Bulletin #2 - Engine noise found mostly in 2004 GM SUV's and Trucks using the OS-2BOSE.
Not a known issue in 2003 SUV's and Trucks.

6-21-04

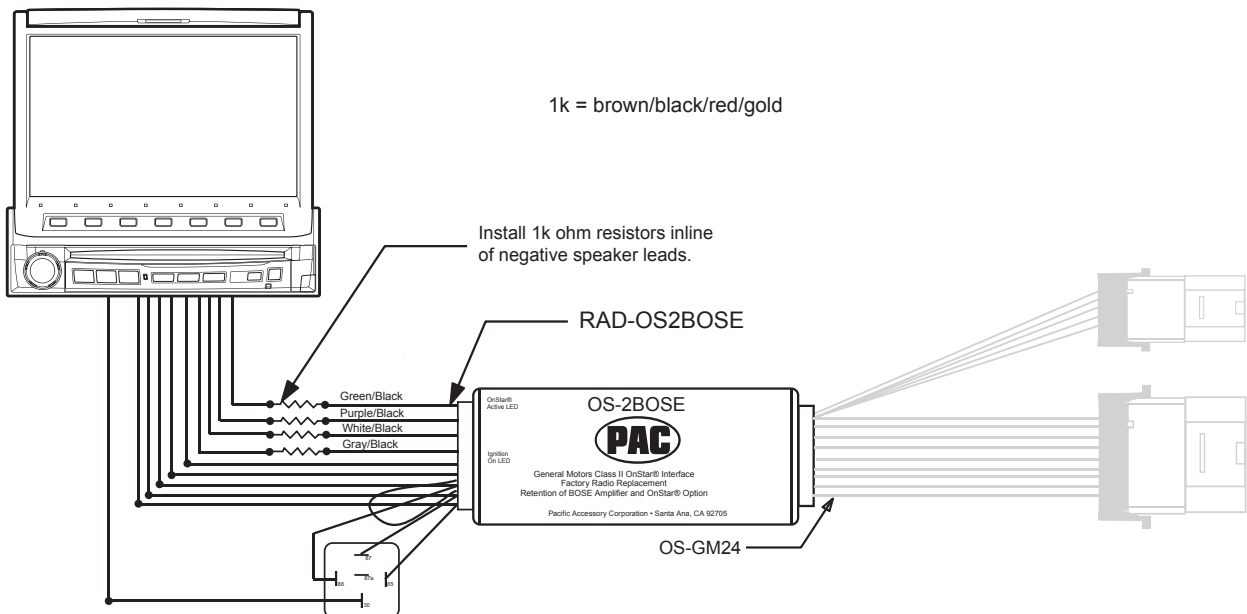
Problem: A problem has arisen when installing the OS-2BOSE in 2004 SUV's and Trucks that engine noise is produced into the audio system. Currently, this is not a known problem in 2003 SUV's and Trucks. Please note that aftermarket flip out monitors may still require Bulletin #1 fix.

Solution: Use the supplied 1k ohm resistors and install them according to the diagram below.
